Service Bulletin SB-912-063 R1 & SB-912-063UL R1
Replacement of fuel pumps for Rotax Engine Type 912 Series

Replacement of fuel pumps for ROTAX® Engine Type 912 (Series)

This SB revises the initial issue dated 24 June 2013.

ATA System: 73-00-00 Fuel system

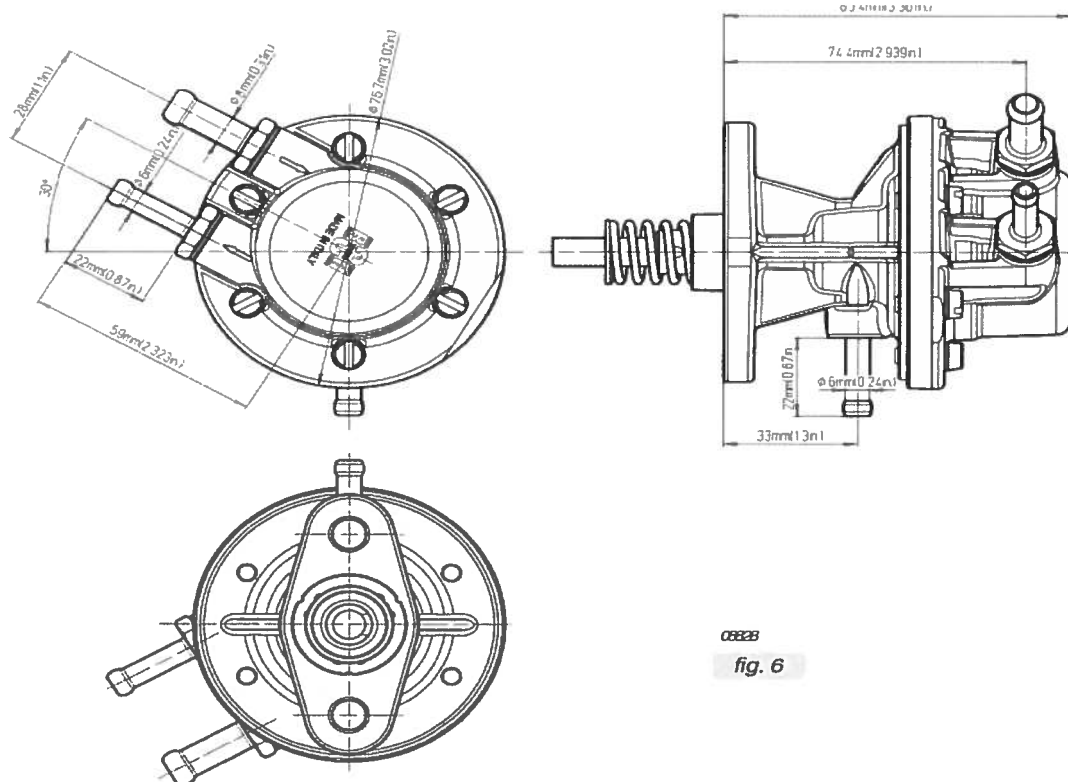
Due to the huge requirement for pumps, requests will be dealt with on a first come first served basis. Please specify if you require a certified pump with an EASA Form 1. Please read the instructions carefully for replacing pumps with fire sleeve. Fuel lines will have to be plugged carefully to stop contamination whilst you wait for the replacement pump to arrive. Before sending back your pump, please ensure that the new version will fit your installation as it is slightly longer – see below (fig 6.).

Fig. 1

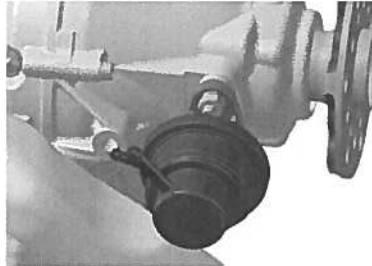
3.1.1) Removal of fuel pump part no. 892542 (without crimped hose assembly), see Fig. 1

Step	Procedure
1	Remove fuel hoses as per aircraft manufacturers instructions. NOTE: Make note of orientation of the hoses (inlet/outlet).
2	Loosen hex. nuts (13 mm/0.51 in) and remove fuel pump with lock washer A8 and insulating flange (gasket).

Fig. 2

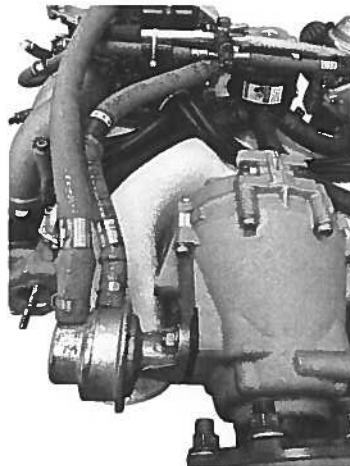
3.1.2) Removal of fuel pump part no. 892546 (with fire sleeve), see Fig. 2

Figure shows fuel pump part no. 892546 with crimped fuel hose assy. and fire sleeve.
Fuel pump

Fig. 3

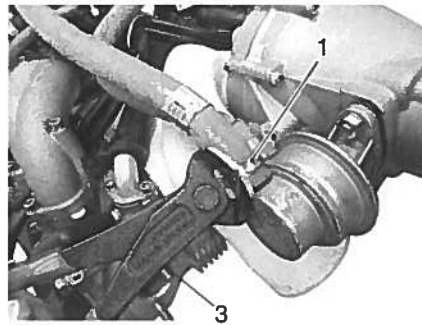
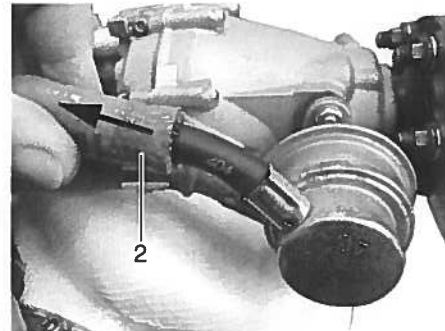
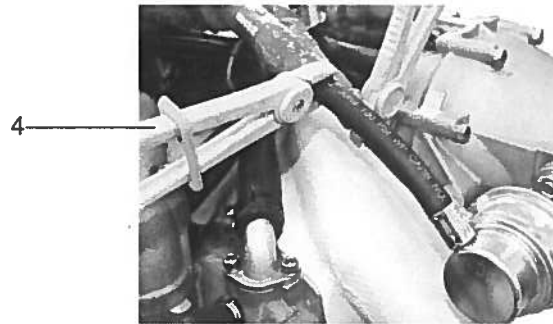
The following work steps are necessary (see Fig. 3):

Step	Procedure
1	Cut off the 1-ear clamp (1) of fire sleeve (2) with cutting pliers (3).
2	Slide back the fire sleeve (2) to make fuel hose accessible for cutting.
3	Pinch off the fuel hose with hose clamp pliers (4).

Fig. 4

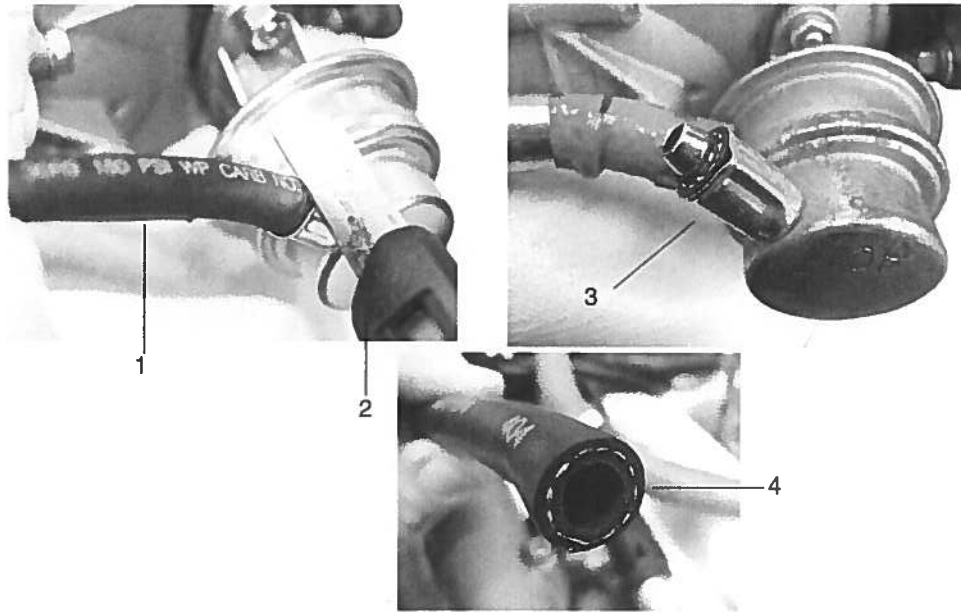
NOTE: Cut off the fuel hose with a very sharp knife, so that no cutting residues are produced. See Fig. 4.

Step	Procedure
4	The cut should be made adjacent to the crimped ferrel, to avoid losing any needed length. The fuel hose is reduced by approx. 20 mm (0.79 in.). NOTE: Make note of orientation of the hoses (inlet/outlet) A clean cut surface is very important!
5	Repeat procedure at the second fuel hose assy.

Fig. 5

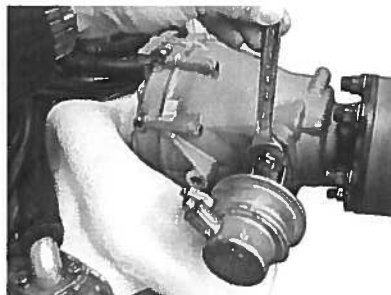
Step	Procedure
6	Loosen hex. nuts (13 mm/0.51 in) and remove fuel pump with lock washer A8 and insulating flange (gasket). See Fig. 5.

Fig. 6

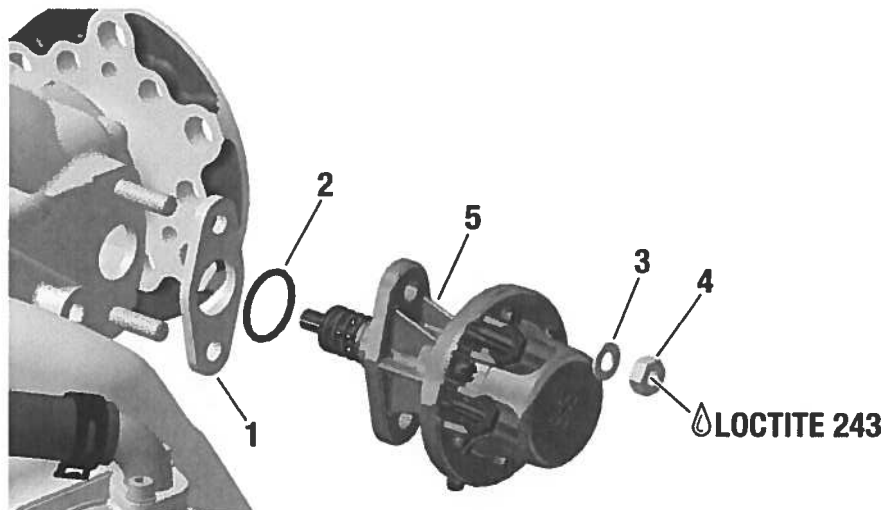
3.2) Assembling of fuel pump assy. part no. 893110

In addition to the insulating flange (gasket) also replace the O-ring at reassembly or assembly of the fuel pump. Both parts are included in the set of fuel pump assy.

Ensure the O-ring is located in the recess in the fuel pump, before installing the fuel pump!

Step	Procedure
1	Install fuel pump (5) with new insulating flange (gasket) (1) and O-ring (2).
2	Secure new hex. nuts M8 (4) and lock washer A8 (3) with LOCTITE 243 and tighten them evenly. Tightening torque 15 Nm (133 in.lb).

Fig. 7

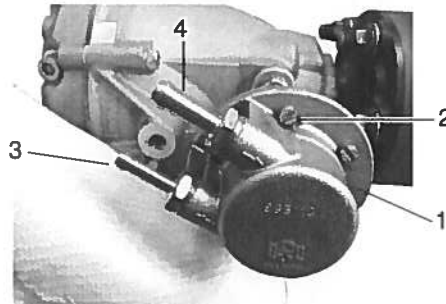
The fuel pump cover (1) must not be opened for inspection. Check the security markings (witness paint) (2).

Check the connecting nipples (3)+(4) for tightness. If necessary secure them with LOCTITE 243. Tightening torque 10 Nm (88.5 in.lb).

Step	Procedure
1	Connect the hose from the fuel tank to the connecting nipple identified as 4 in Fig. 7.
2	The hose that goes to the carburetors should be connected to the connecting nipple identified as 3 in Fig. 7. NOTE: After installation of the hoses ensure the fuel tap is turned back ON.

Fig. 8

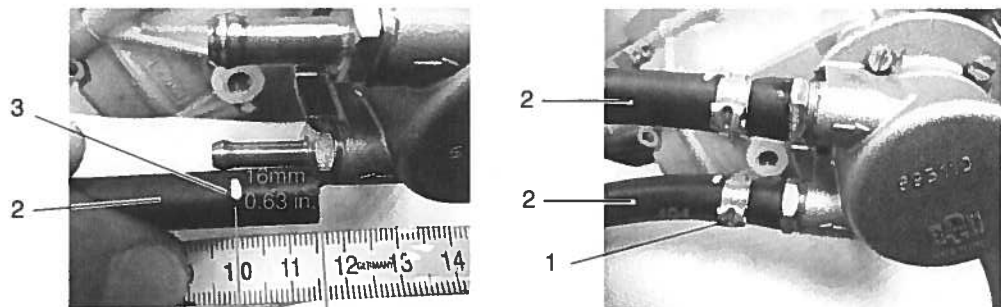
3.4.2) Assembling of the fuel pump part no. 893110 when replacing fuel pump part no. 892546

Step	Procedure
2	Before the fuel hose (2) is fitted with a 1-ear clamp (1), the two fuel hoses have to be marked (3) 16 mm (0.63 in.) from the end of the hose (2).
3	Slide all 4 1-ear clamps (1) on the fuel and fire sleeves. NOTE: Clamps part no. 853313/851663 on fire sleeve and clamps part no. 851463/851453 on fuel hose.
4	Slide the fuel hoses (2) onto nipple completely up to the end stop.
5	Crimp 1-ear clamp (1)- outlet side part no. 851463 with suitable crimp pliers . NOTE: The edge of the 1-ear clamp (1) must align with mark (3) from fuel hose (2) , because otherwise there is too little space for the 1-ear clamp (1) of the fire sleeve.
6	Repeat steps on inlet-side with 1-ear clamp (1) part no. 851453 for fuel hose assy. (2).

Fig. 9

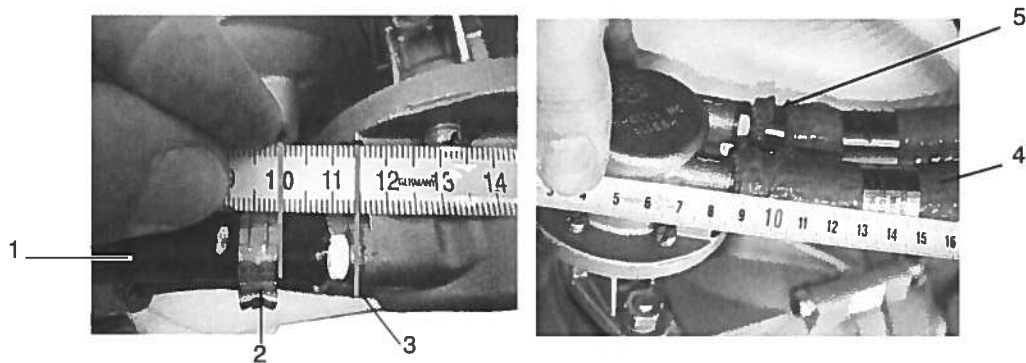
The distance from the 1-ear clamp (2) to the nipple flange (3) has to be measured, so that the outer 1-ear clamp (5) can be mounted on the fire sleeve (4) in the correct position.

Step	Procedure
1	Measure the distance at fuel hose assy. (1) from 1-ear clamp (2) to nipple flange sealing surface (3) and mark the fire sleeve (4) correspondingly. NOTE: The clamp securing the fire sleeve should be as close as possible but without impeding on the fuel hose clamp

Fig. 10

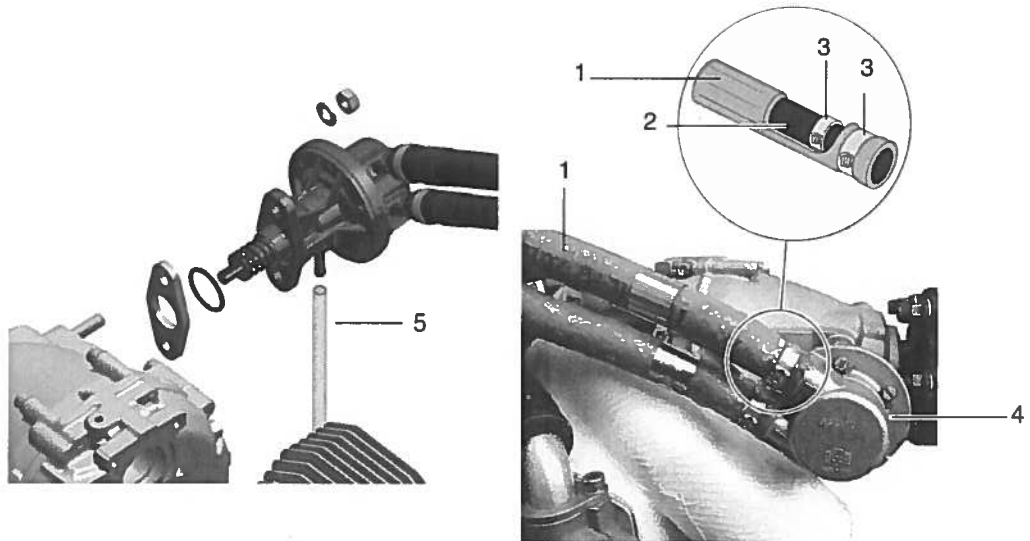
Step	Procedure
2	Push fire sleeve (fuel inlet) to stop and mount 1-ear clamp (17.8-21.0 mm/0.70-0.83 in.) with suitable crimp pliers.
3	Repeat steps for fire sleeve (fuel outlet) (22.4-25.6 mm/0.88-1.01 in.).

A drain line must be installed, that in the event of a internal leak any fluid is drained to a suitable location/position. See therefore Installation Manual of the relevant engine type and SI-912-020.
